# Monthly Specification Update

**Intel® Server Board S5520UR**

*Intel Order Number E69054-001*

**Sep 2012**

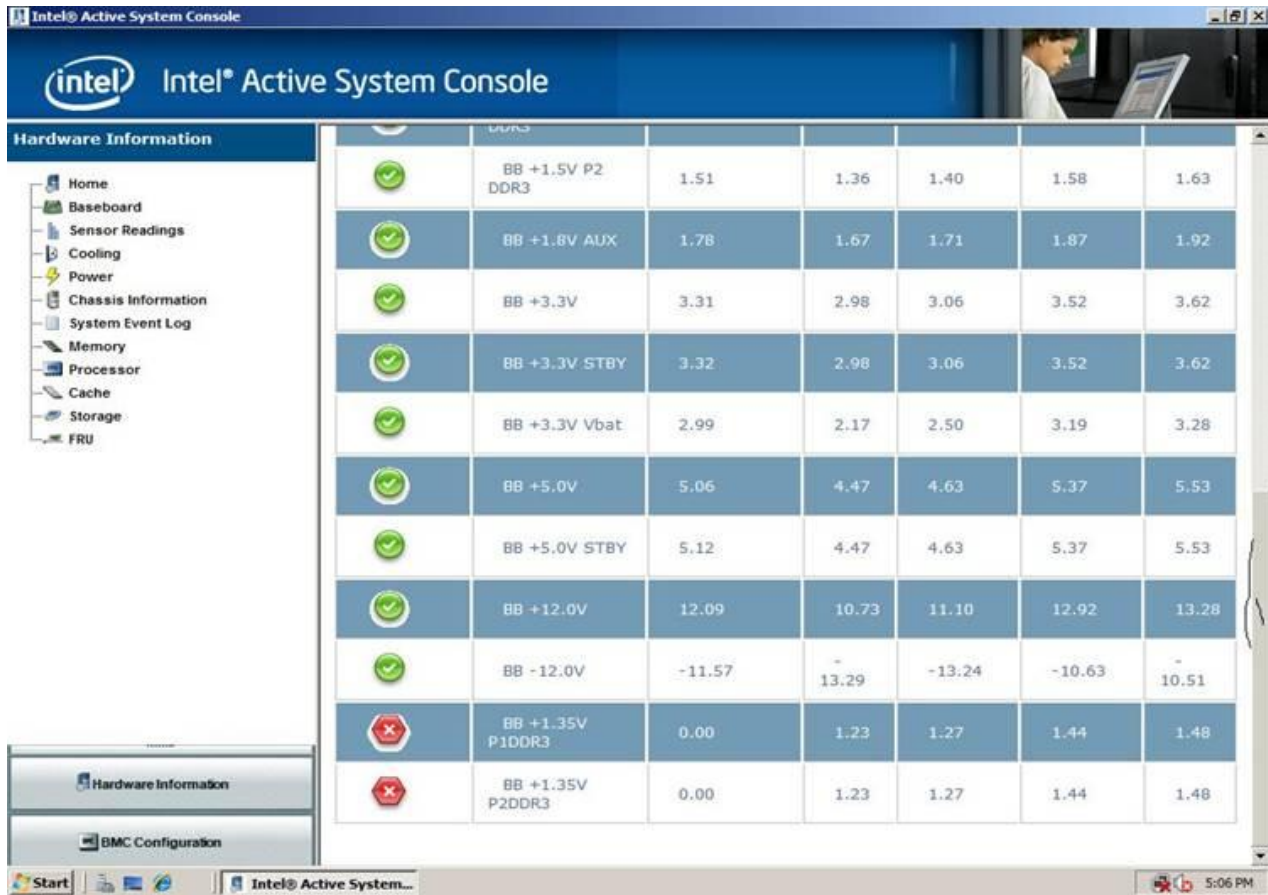
Problem	<p>Intel® Active System Console (IASC) v3.5.1 and v3.5.2 is used to monitor hardware status on Intel server system.</p> <p>Intel® Server Board S5520UR start to support low voltage memory DIMM, so current FRUSDR has contained four memory voltage sensors "BB+1.5v P1DDR3", "BB+1.5v P2DDR3", "BB+1.35v P1DDR3" and "BB+1.35v P2DDR3", When system has 1.5v memory or 1.35v memory, only corresponding memory voltage sensors will be enabled, the other type memory voltage sensors will be disabled.</p> <p>IASC cannot judge the status of memory voltage sensors which have been disabled, and still try to detect those sensors reading. Because sensor reading is "0", lower than its threshold, so IASC shows those sensors status as critical warning.</p> <p>Below is screen shoot of this failure</p>
---------	--

**Status** This issue will be fixed on next IASC release.

**Figure 1. Removing the Heatsink**

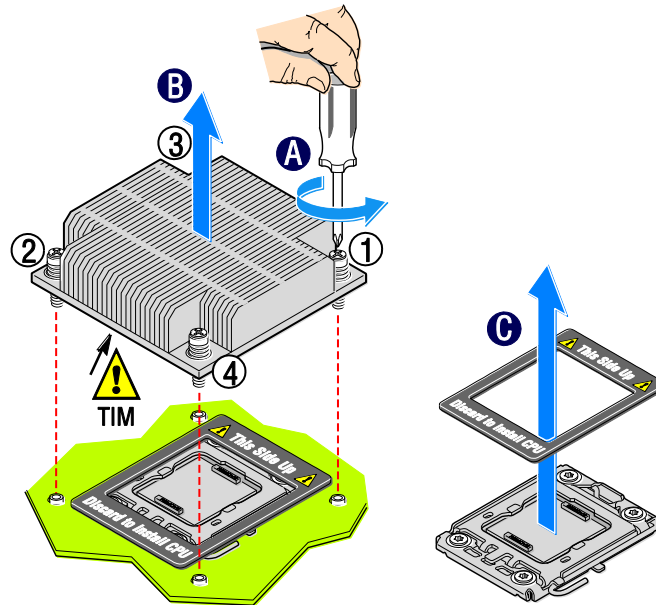
**Problem:** The current documentation does not properly describe the installation and removal of the heatsink. Careful insertion and removal of the heatsink is required to prevent damage to the heatsink screws or backplate.

1. Loosen the four captive screws on the heatsink corners in a diagonal manner according to the numbers shown in figure 1 as follows:
  - Starting with the screw at location 1, loosen it by giving it **two rotations** in the anticlockwise direction and stop. (**IMPORTANT:** Do not fully loosen.)
  - Proceed to the screw at location 2 and loosen it by giving it two rotations and stop.
  - Loosen screws at locations 3 and 4 by giving each screw two rotations and then stop.
  - Repeat steps 1a through 1c by giving each screw two rotations each time until all screws are loosened.
2. Do one of the following:
  - If removing the heatsink for the first time, do the following:
    - i. Lift the heatsink from the board.
    - ii. Remove and discard the spacer (see letter “C” in figure 1).

**Status:** Corrections incorporated into the latest version of the following Service Guides:

Figure 2: Installing the Heatsink

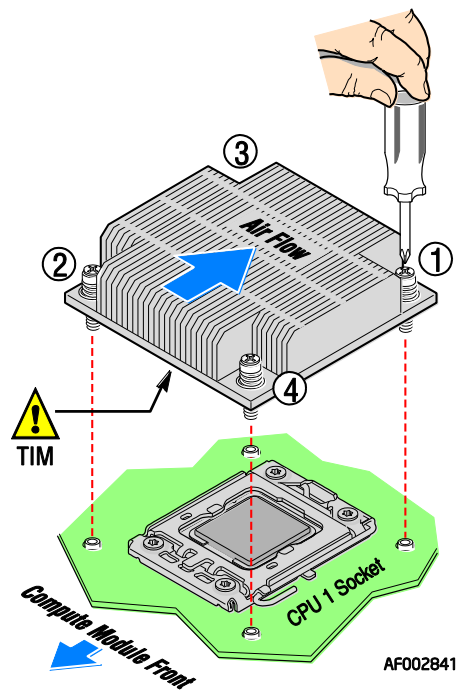
2. Orient the heatsink over the processor as shown in Figure 2. The heatsink fins must be positioned as shown to provide correct airflow through the system.

3. Set the heatsink over the processor, lining up the four captive screws with the four posts surrounding the processor.
4. Loosely screw in the captive screws on the heatsink corners in a diagonal manner according to the numbers shown in Figure 2 as follows:

- b. Proceed to the screw at location 2 and engage the screw threads by giving it two rotations and stop.
  - c. Engage screws at locations 3 and 4 by giving each screw two rotations and then stop.

- d. Repeat steps 4a through 4c by giving each screw two rotations each time until all screws are lightly tightened upto a maximum of 8 inch-lbs torque.
